RE: Addendum – Chevron-1 to Houston Community College – Alief Center Renovation

## **ADDENDUM – Chevron-2**

RE: Addendum – Chevron-2 to Houston Community College – Alief Center Renovation

### **ADDENDUM – Chevron-3**

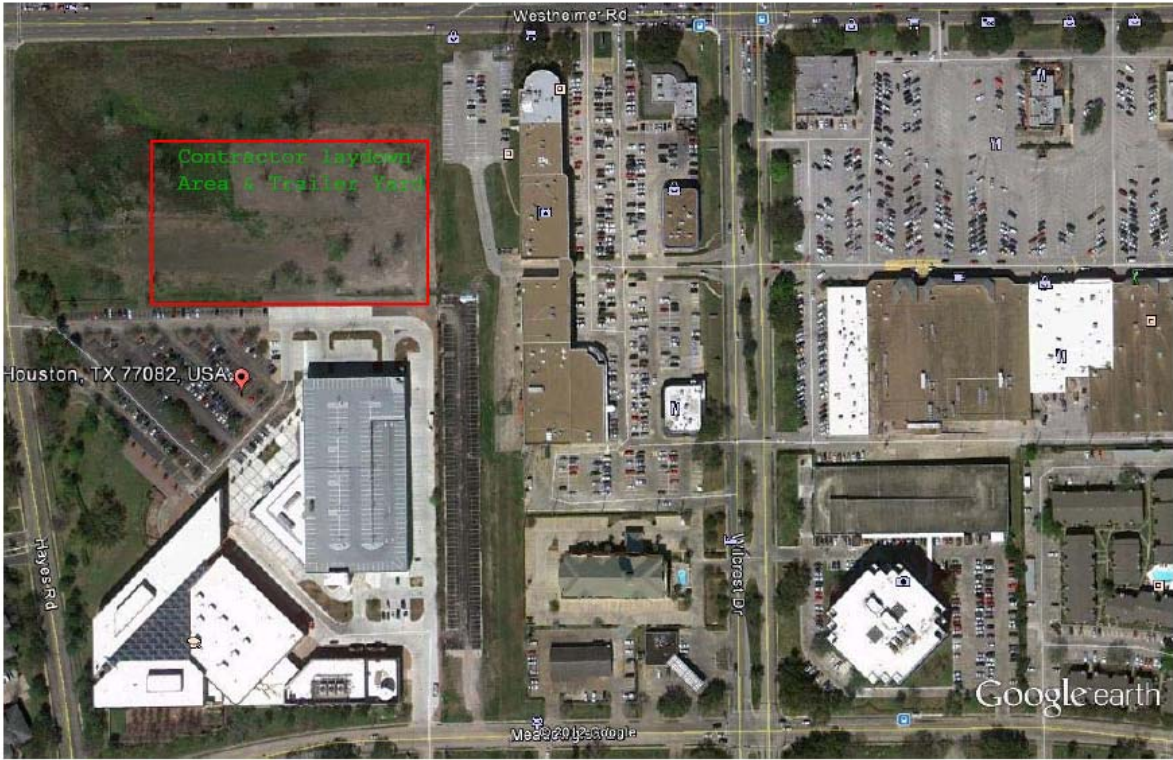
- 2) There will be lay down area available for the Contractors. It will be located north of the Alief Center parking lot; map is attached at the end of this document. General Contractor shall provide security fence around area shown. Bidder shall be responsible for secure containers as required.

DRAWING NUMBER  
**M.406**

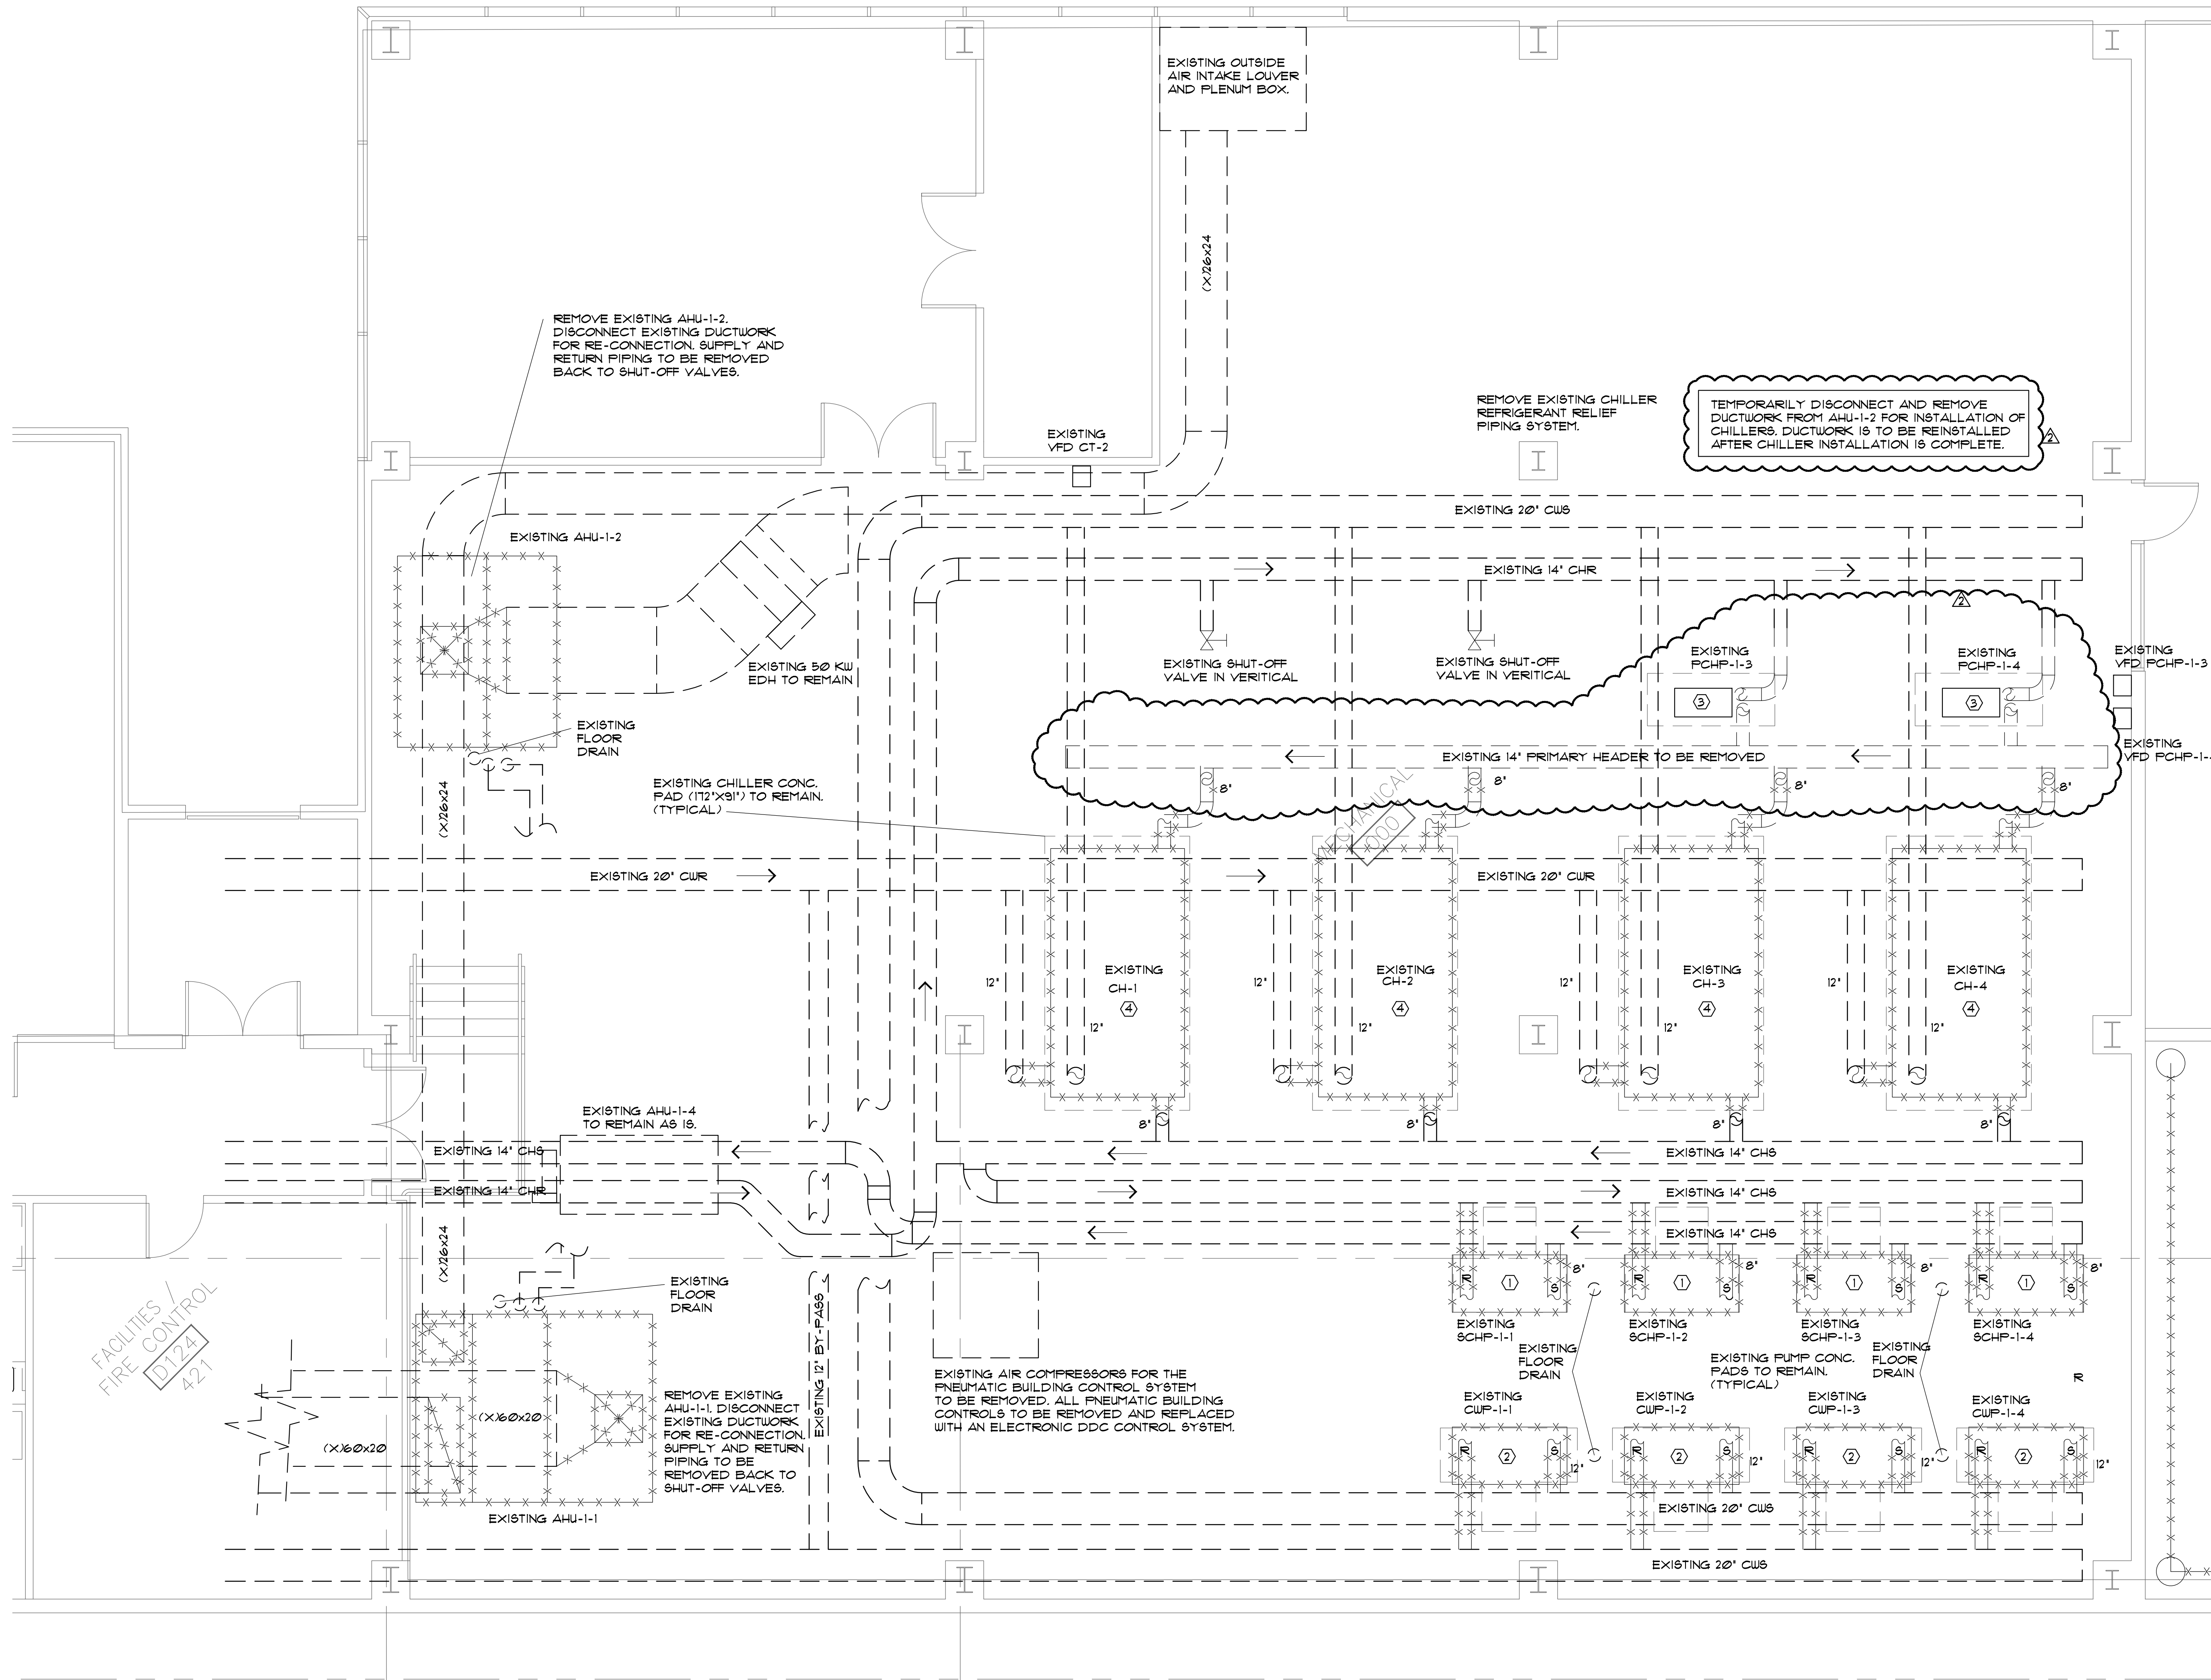
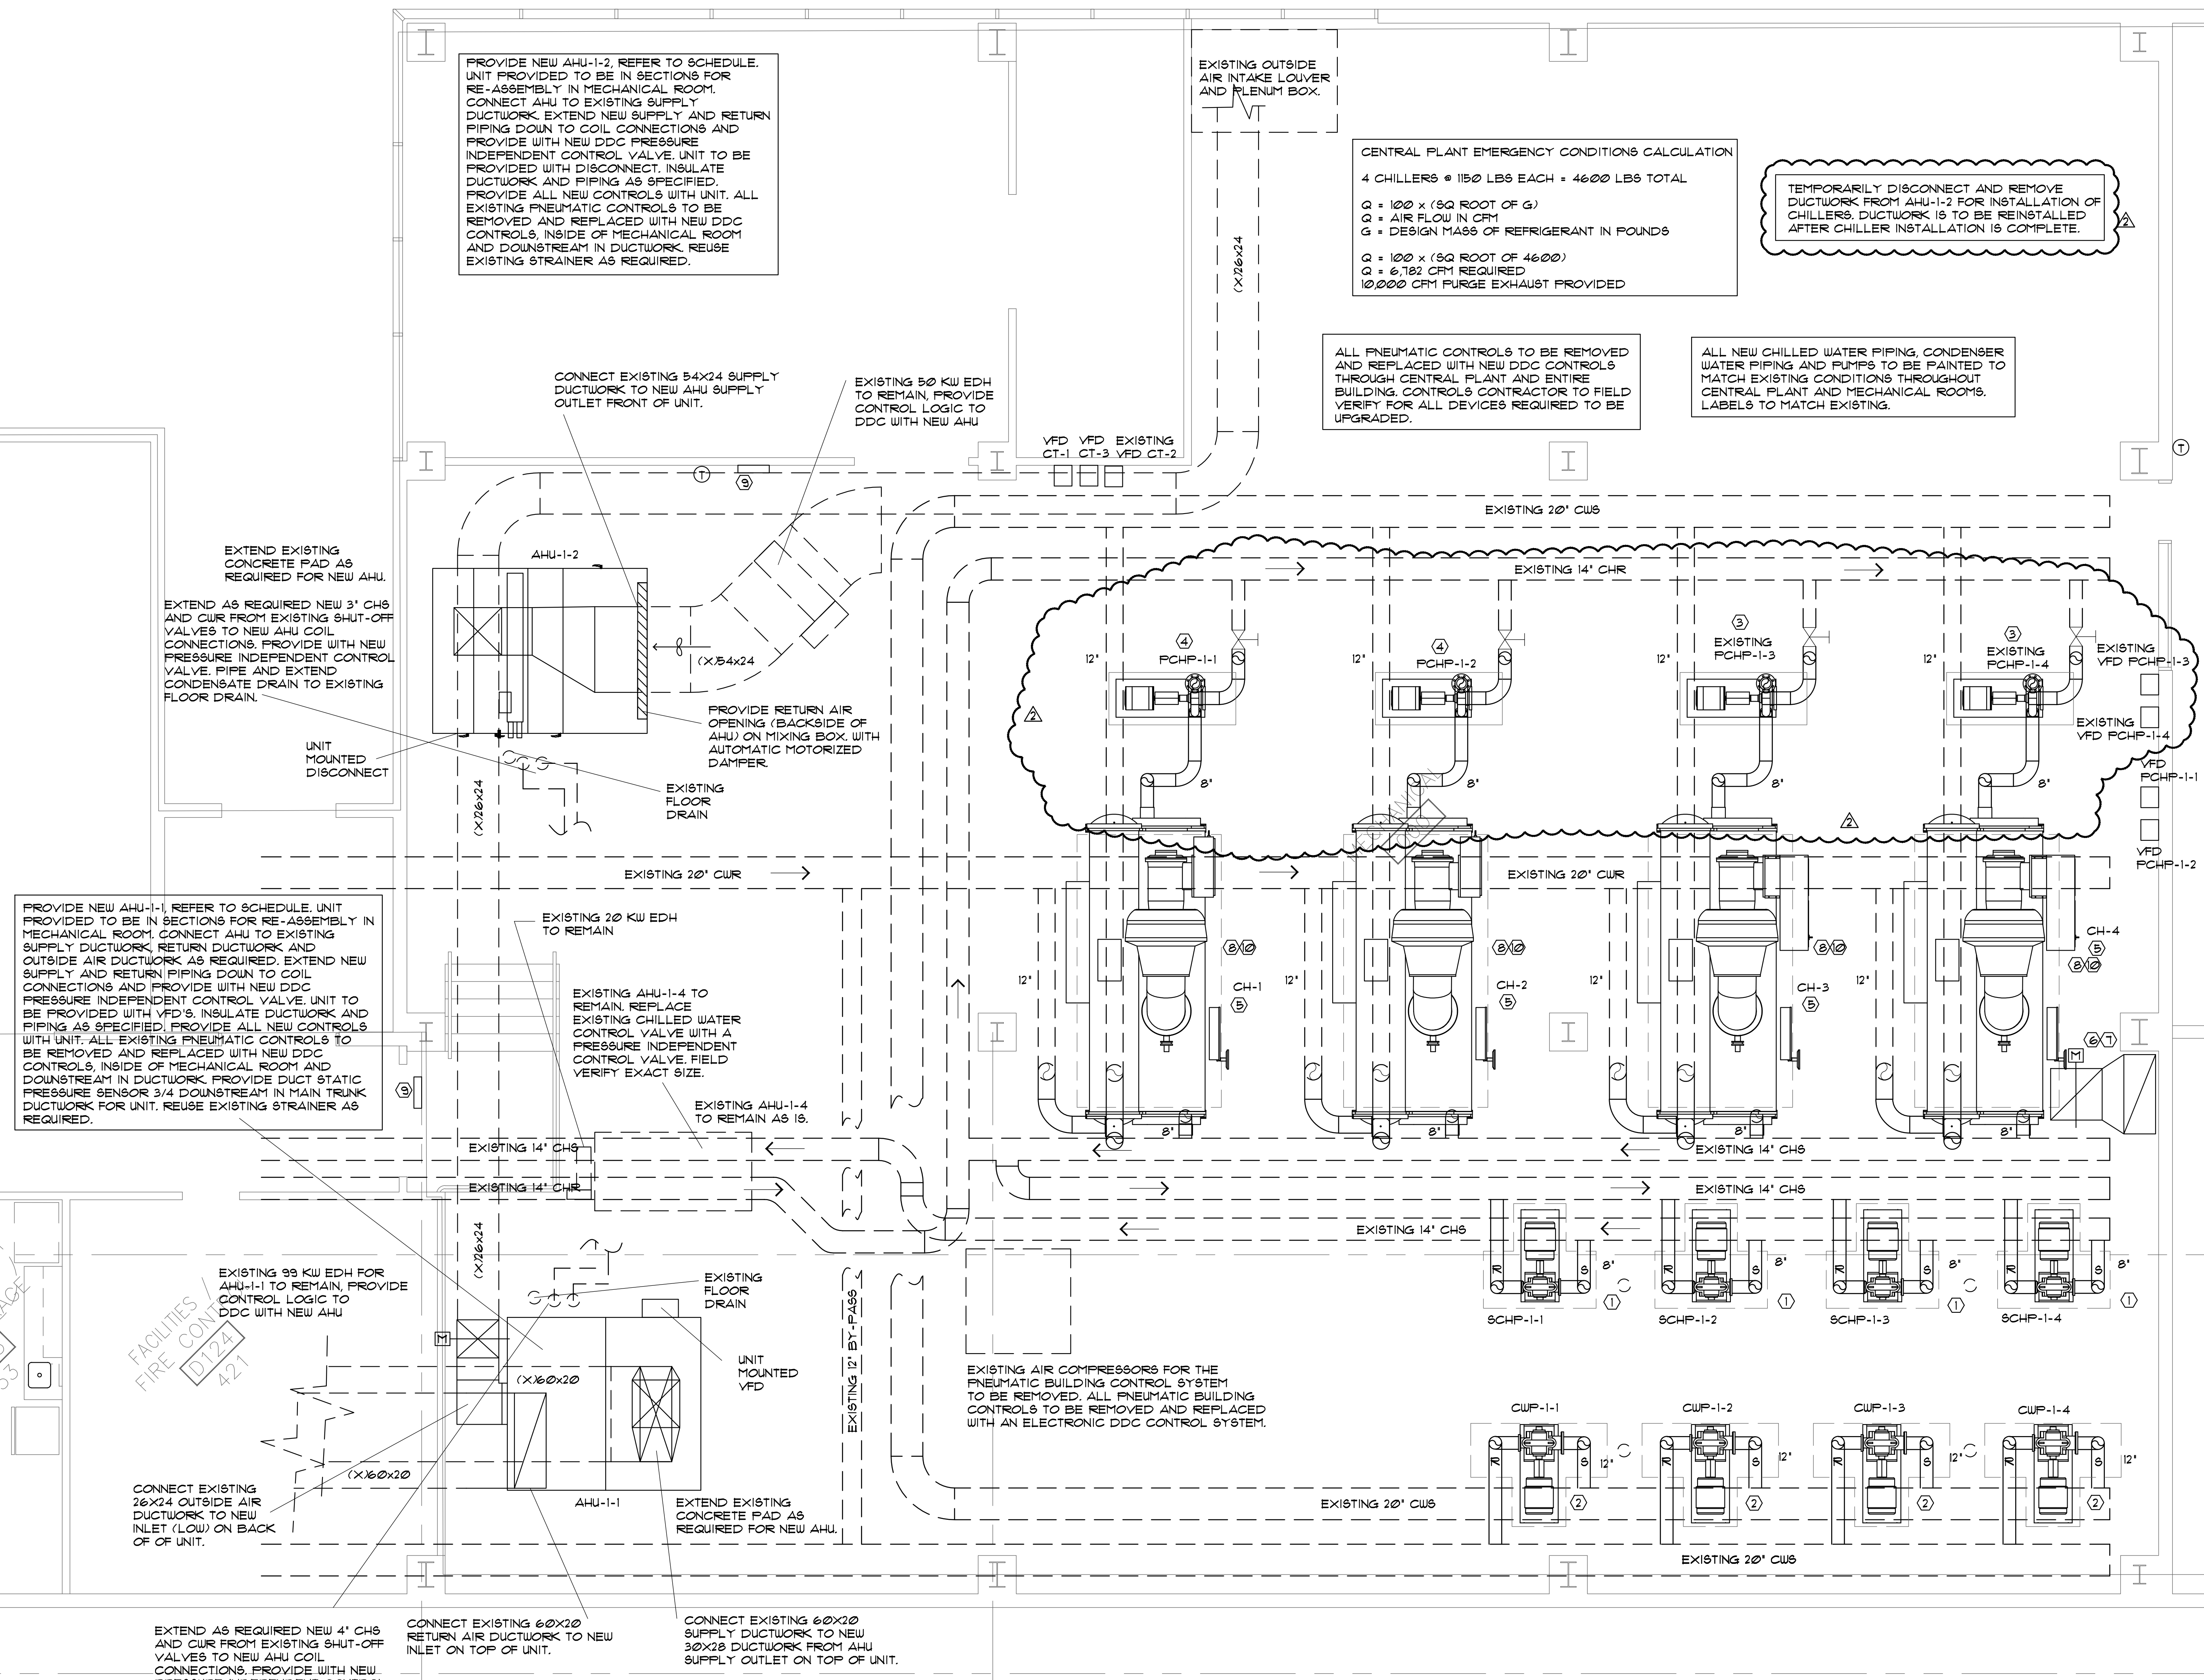
- 4) Painting specified on Sheet M.406 shall be by Bidder.
- 5) New equipment pads required for mechanical work shall be provided and installed by Bidder.

ALL NEW CHILLED WATER PIPING, CONDENSER WATER PIPING AND PUMPS TO BE PAINTED TO MATCH EXISTING CONDITIONS THROUGHOUT CENTRAL PLANT AND MECHANICAL ROOMS. LABELS TO MATCH EXISTING.

- 10) Bidder shall include a project schedule with his/her bid.
- 11) EF-1 shall be equipped with 2-speed motor.
- 12) ELAP-1 and ELAP-2 shall be rotated 90 degrees, coordinate exact location/orientation with Chevron Energy Solutions Project Manager and Engineer.

- ⑥ 50x20 DOWN TO 12" AFF. BOTTOM END OF DUCT TO BE LEFT OPEN WITH BIRD SCREEN OVER OPENING.
- ⑦ 36x36 UP TO EF-1 ON ROOF. EF-1 TO BE INTERLOCK WITH EMERGENCY FURGE VENTILATION SYSTEM.
